Subject: RE: SSD 9667 - Light Horse Interchange Business Hub, Eastern Creek Response to Submissions

Jemena has taken the opportunity to review the applicants response to submission for the SSD 9667 – Light Horse Interchange Business Hub and we now provide a supplementary response to clarify Jemena’s position (17th September 2019) on the proposed development and its interface with Jemena's existing buried high pressure gas pipeline.

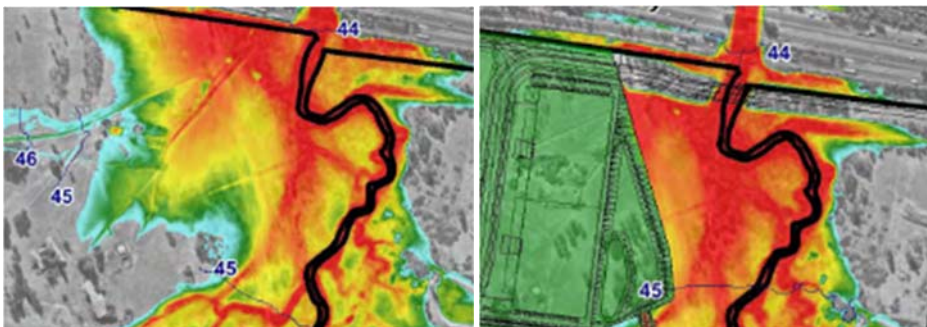
1. the road crossing: There is some loose requirements that load bearing is considered on the Jemena pipeline. Jemena requests that it be contacted and approval sought in order to obtain design and construction requirements for and load bearing slabs over the pipeline and requirements to allow the road to be constructed (i.e. integrity digs, possible re -wrapping of the protective coating of the pipeline etc)

2. the retention basin overflow: The overflow is intended to have undirected flow over the gas pipeline easement in flood events. Jemena would like some detail regarding how often this basin is likely to overflow.

3. the change to flood affects: The gas easement appears as if it will now suffer more severe flooding due to the impact of the development. Jemena may need to consider the more pronounced and frequent effects of buoyancy of the pipeline due to flooding.
